United States Patent and Trademark Office

APPLICATION NO.	FILING DATE	FIRST NAMED INVENTOR	ATTORNEY DOCKET NO.	CONFIRMATION NO.	
10/656,324	09/08/2003	Bor Yann Chuang	BHT-3117-157	9202	
7590 11/02/2005			EXAM	EXAMINER	
TROXELL LAW OFFICE PLLC			SELF, SHELLEY M		
5205 LEESBURG PIKE, SUITE 1404 FALLS CHURCH, VA 22041			ART UNIT	PAPER NUMBER	
	o, v ==v		3725

01				
	Application No.	Applicant(s)				
	10/656,324	CHUANG, BOR YANN				
Office Action Summary	Examiner	Art Unit				
	Shelley Self	3725				
The MAILING DATE of this communication appears on the cover sheet with the correspondence address Period for Reply						
A SHORTENED STATUTORY PERIOD FOR REPLY IS SET TO EXPIRE 3 MONTH(S) OR THIRTY (30) DAYS, WHICHEVER IS LONGER, FROM THE MAILING DATE OF THIS COMMUNICATION. - Extensions of time may be available under the provisions of 37 CFR 1.136(a). In no event, however, may a reply be timely filed after SIX (6) MONTHS from the mailing date of this communication. - If NO period for reply is specified above, the maximum statutory period will apply and will expire SIX (6) MONTHS from the mailing date of this communication. - Failure to reply within the set or extended period for reply will,

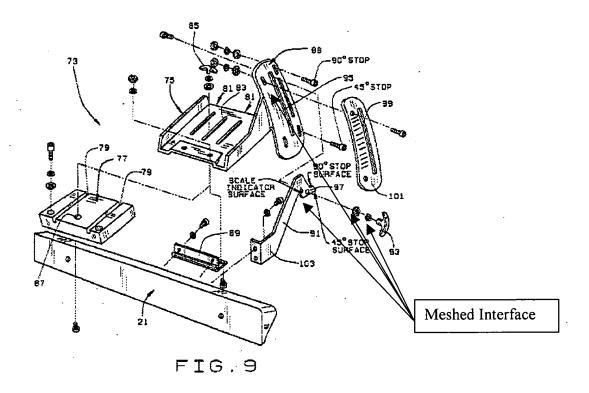
Claims 8-11 and 13-22 as best as can be understood are rejected under 35 U.S.C. 102(b) as being anticipated by Jedlicka et al. (5,533,557). With regard to claim 8, Jedlicka discloses an adjustable stop plank for a power tool (fig. 1) having a work surface (7, 9), the adjustable stop plank further comprising: a drive mechanism (23, 27, 47, 75, 89, 91, 113, 127, 129) connected to

the stop plank (21) for continuous adjustment of an angle (col. 7, lines 53-67 to col. 8, lines 1-8; 50-61) of the stop plank (21) with respect to the work surface within a predetermined range of angles, and an actuator (55, 93, 137) for operating the drive mechanism (23, 27, 47, 75, 89, 91, 113, 127, 129) to adjust the angle of the stop plank (col. 7, lines 53-67 to col. 8, lines 1-8; 50-61).

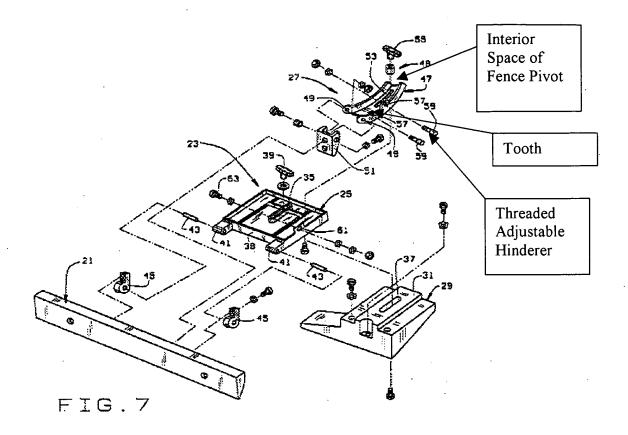
With regard to claims 16 and 17 as best as can be understood, Jedlicka inherently discloses wherein the at least one stop comprises an adjustable hinderer/bolt (59,63) which may be adjusted to obstruct movement of the stop plank (21) beyond the at least one predetermined angle. Examiner notes that Jedlicka's threaded engagement of the at least one stop (59, 63) inherently lends to adjustability of the stop, i.e., threadably engaging the fence pivot (47) completely through the hole (57) into the interior space of the fence pivot (47) will lend to a different stop angle of the stop plank (21) than adjusting the stop (59) only on one side of the hole (57) and not into the interior space of the fence plate (fig. 6).
